**Letter of Objection to the development at Former Tower
Car Sales, Tower Close, East Grinstead, West Sussex (now known as
Whittaker House, 1 Leppard Walk) and
retrospective application DM/26/0432**

The opaque glass is now our back door and access to the bin and bike stores, with the electrical cupboard in place of the hallway to a dedicated entrance

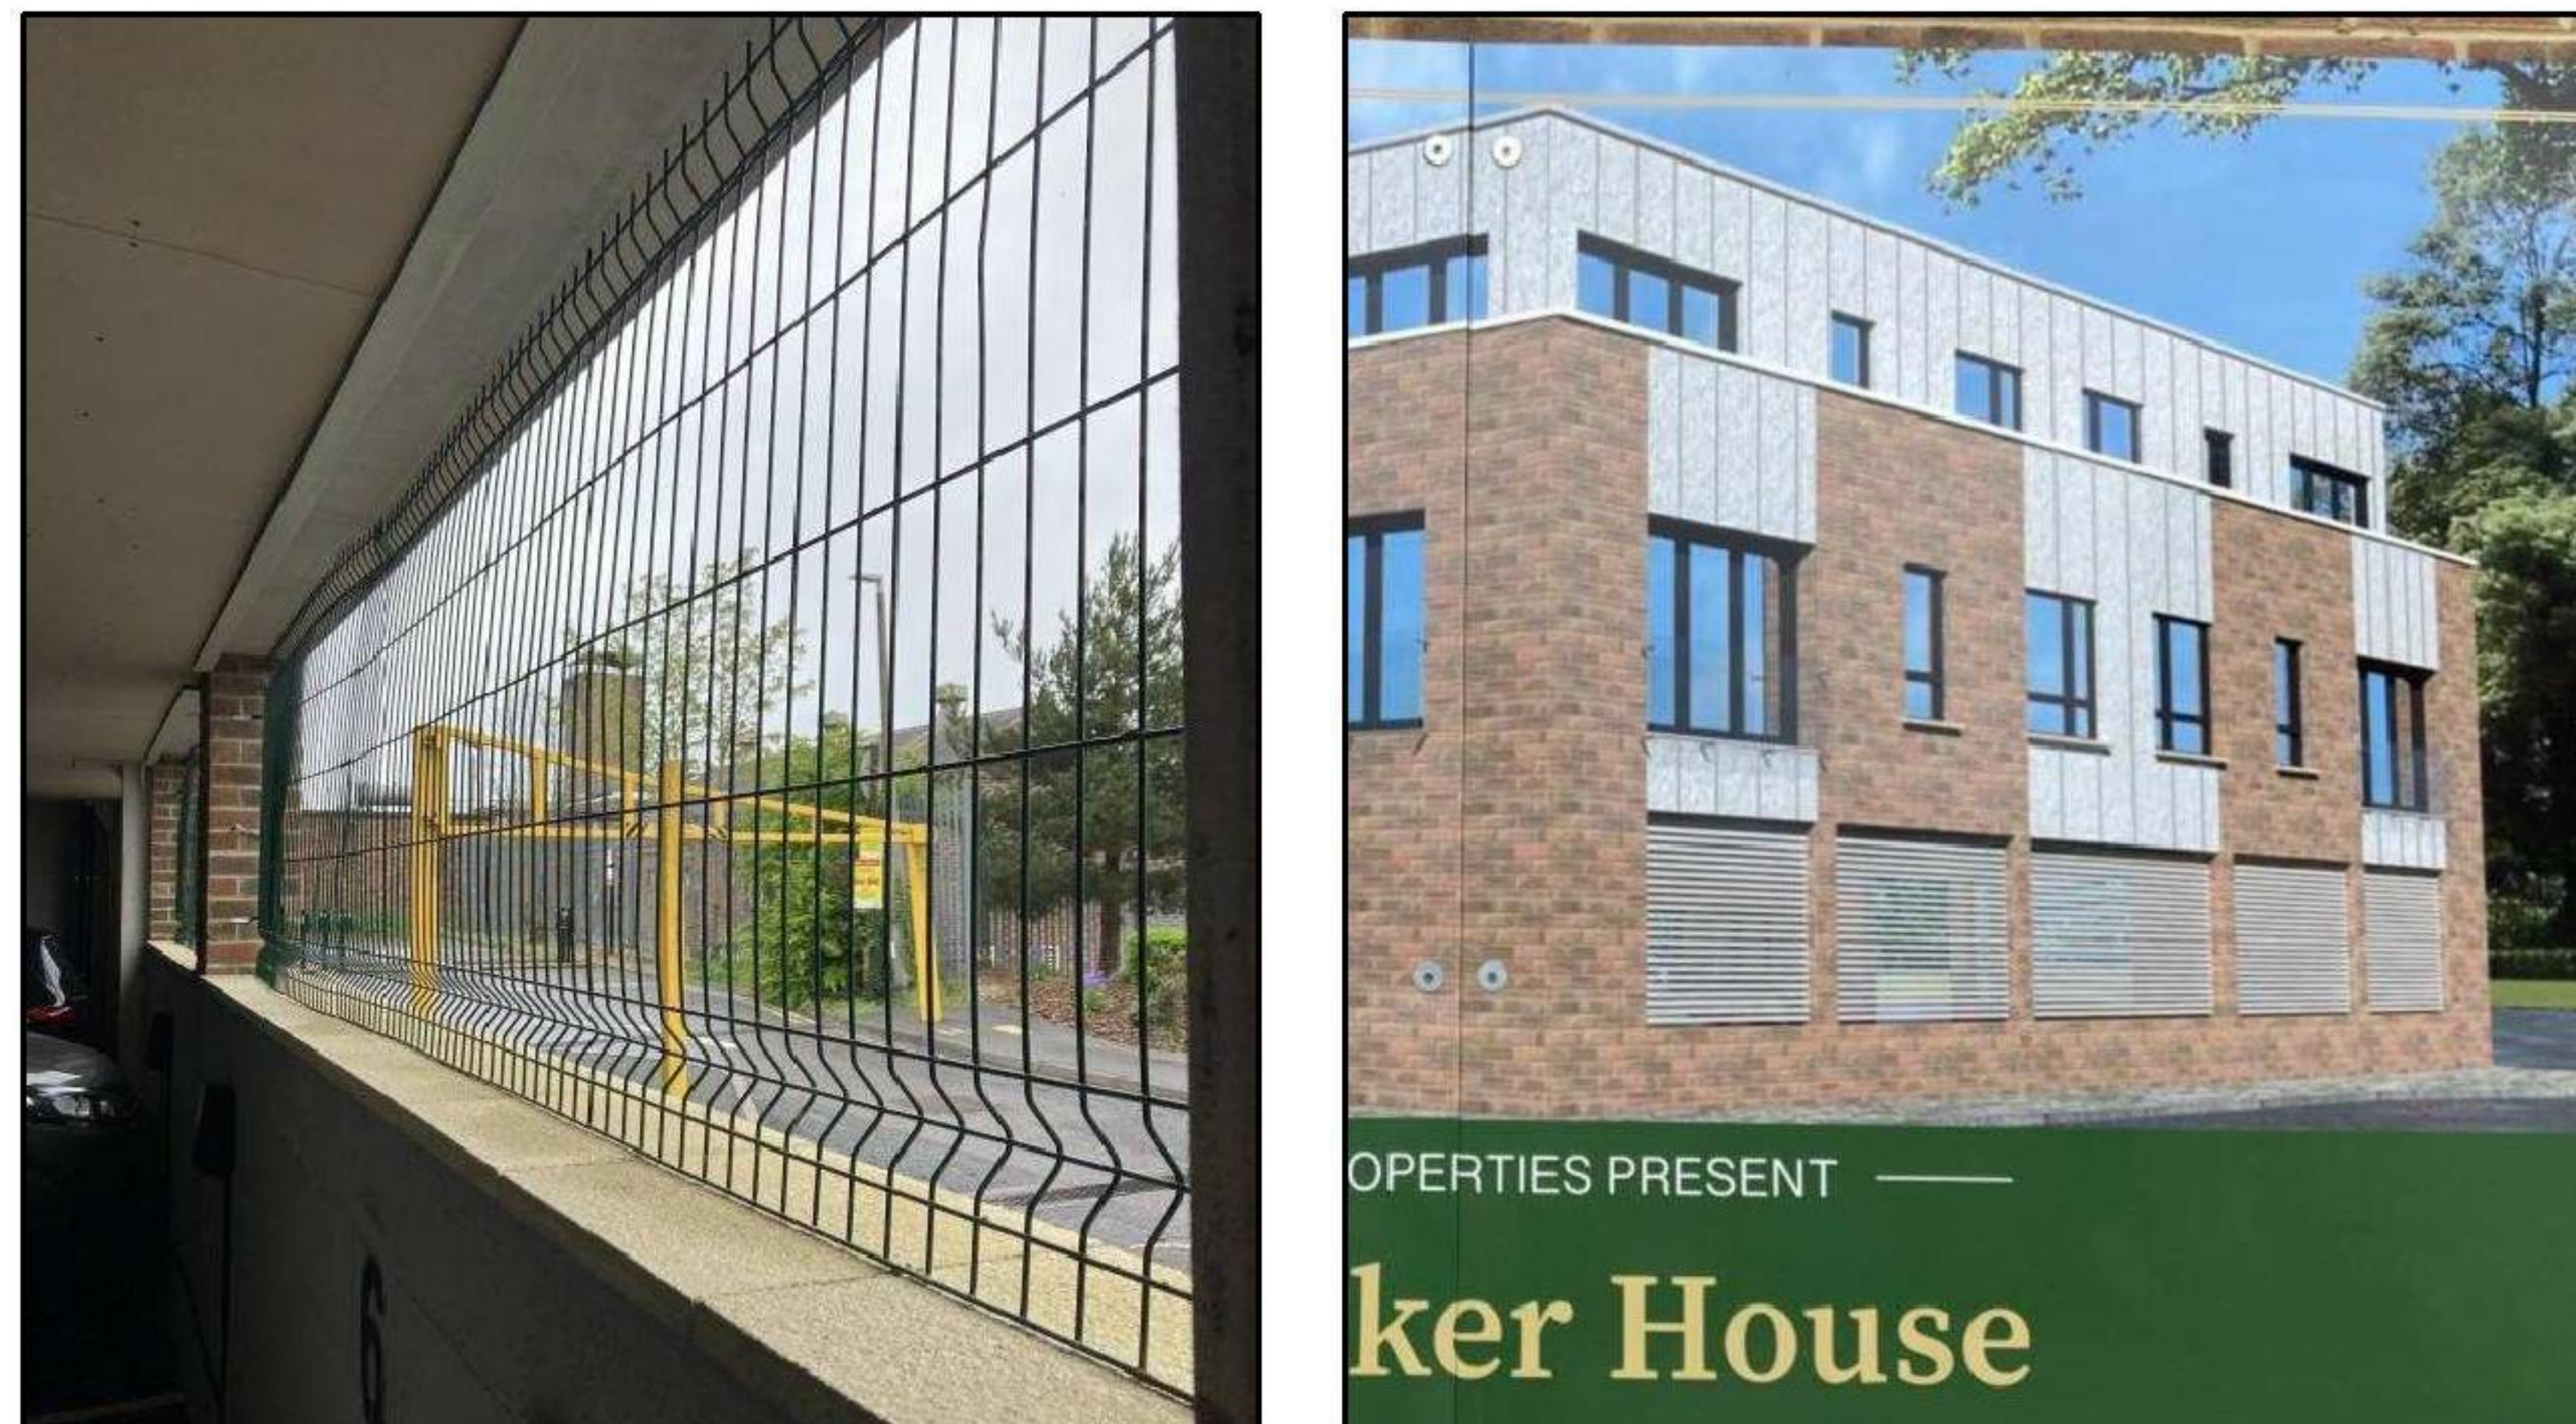
Planning permission for Whittaker House was granted on the expectation that residents would not need to enter through the undercroft, and they would have a dedicated entrance. This has also been sacrificed to make room for a potential 10th flat, with the entrance now located within the undercroft. None of the entry systems, neither internal nor external, have ever worked. The developer has been reached out to numerous times to correct this, but as of writing, no one in Whittaker House is able to receive guests, or secure deliveries, without either getting telephoned first or waiting outside the property. This is yet again more proof of the developers lack of character, and the disparity between what both we and the Planning Office were sold versus what was delivered.

The opaque glass has now been replaced with a back door, which accesses the bin and bike storage and takes us past Flat 1A's front door. The area under the stairs, which was supposed to be our hallway through to a front door, is now the cupboard where all our meters are stored. Further proof that the developer had no intention of building to plan, permission, or sales materials:

The sales poster for Whittaker House (also submitted in plans); The current car park grills

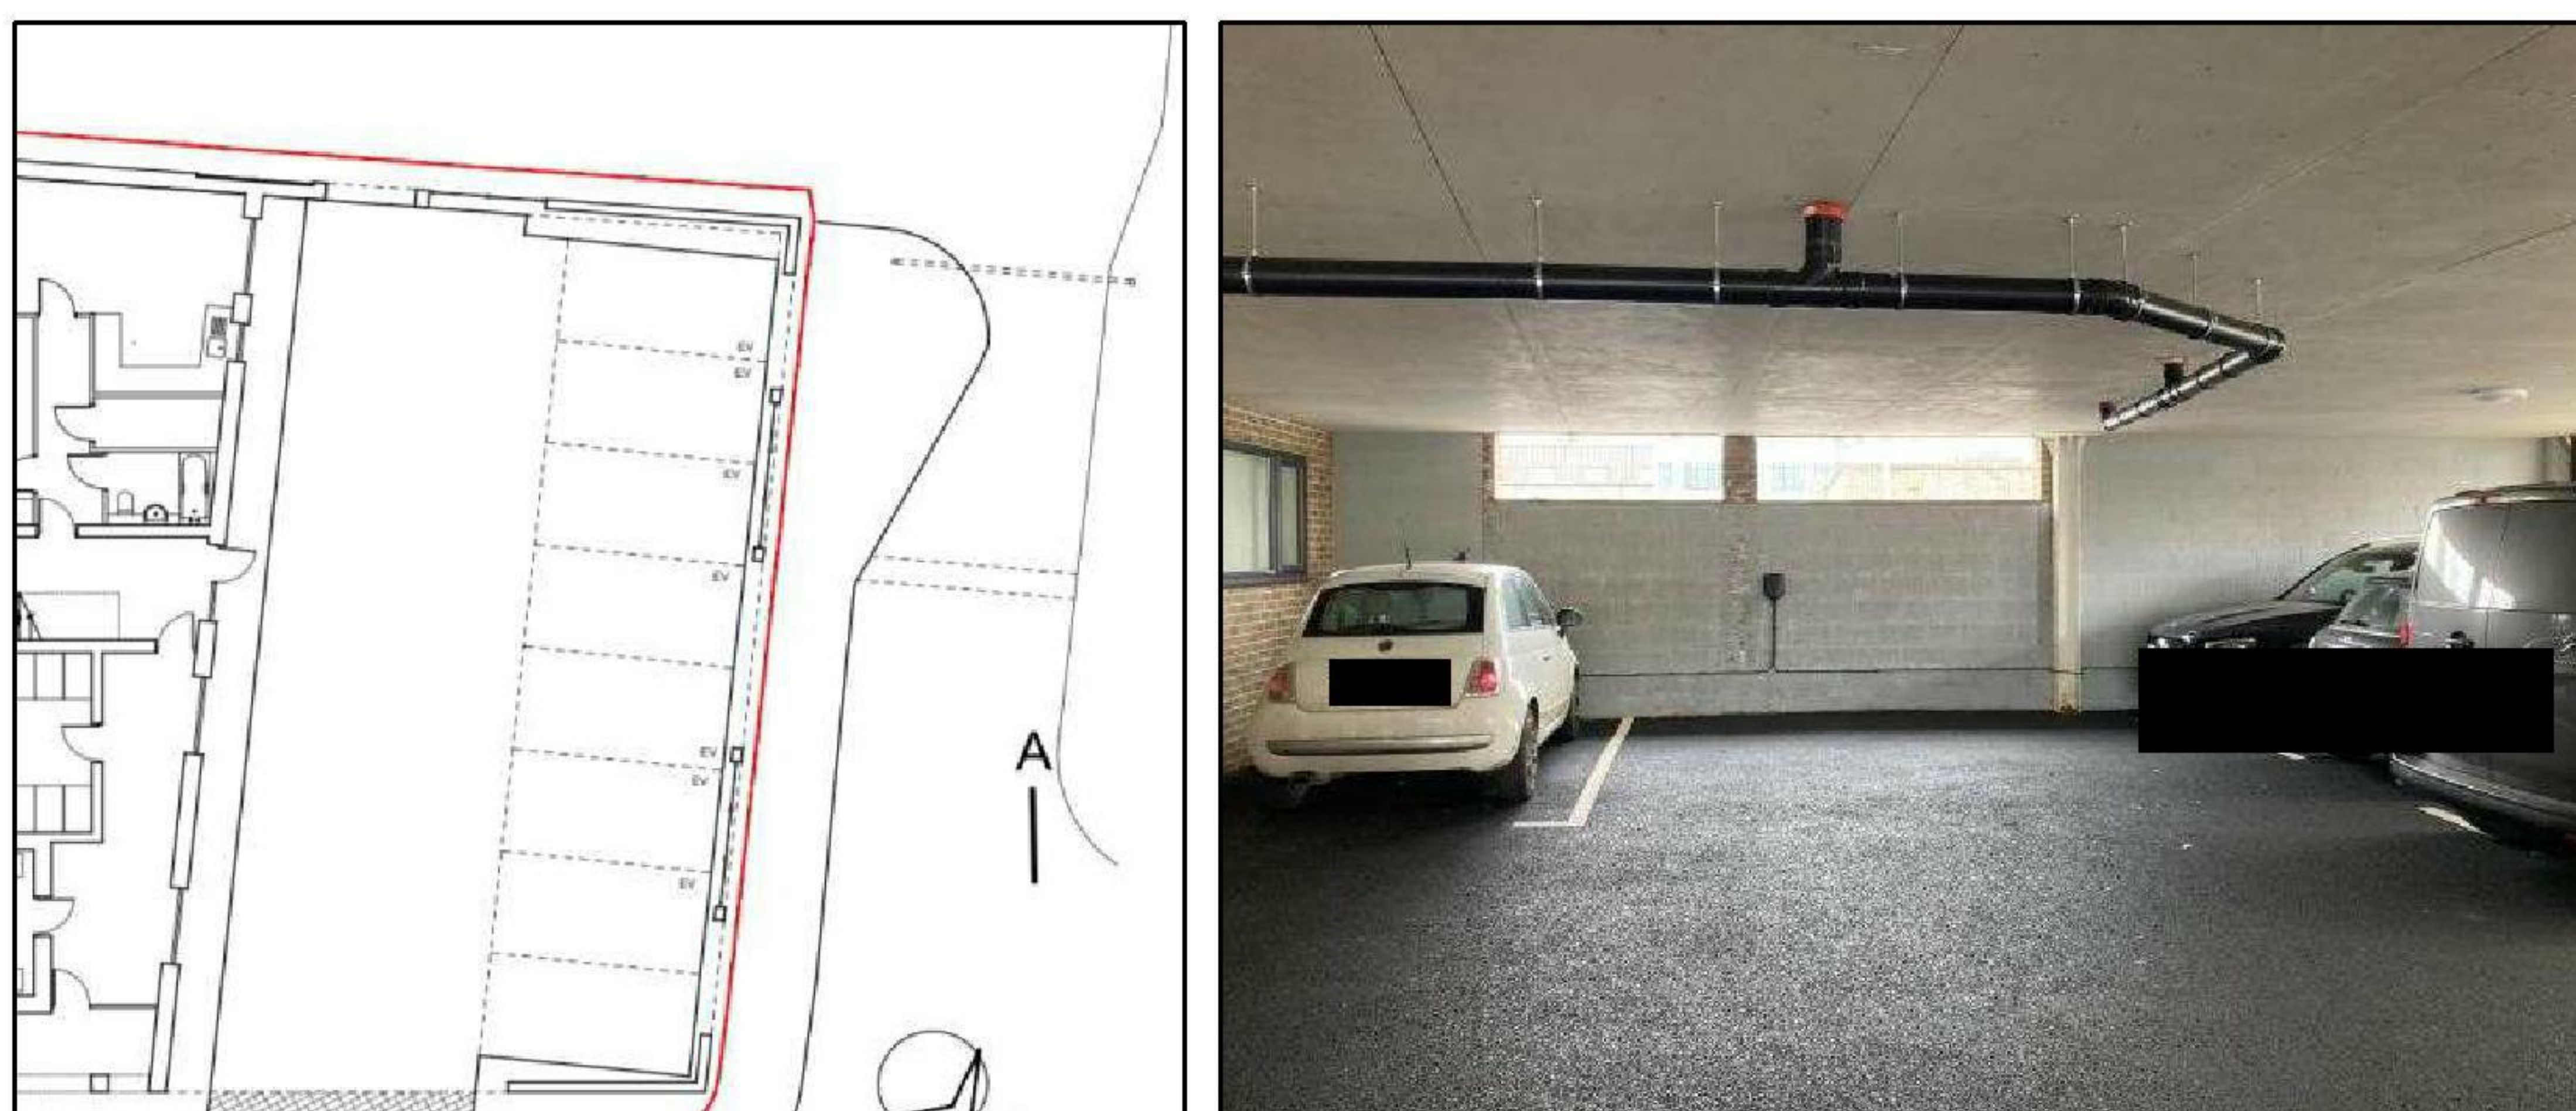
This was originally designated for 8 parking spaces, with tasteful exterior slats (or filigreed metal screens, depending on the submitted pictures). What we have been given more closely represents a snipers nest in Fallujah. This has a considerable effect on the exterior appearance of the building, and combined with the new front facing refuse area, significantly lowers the appearance of the neighbourhood:
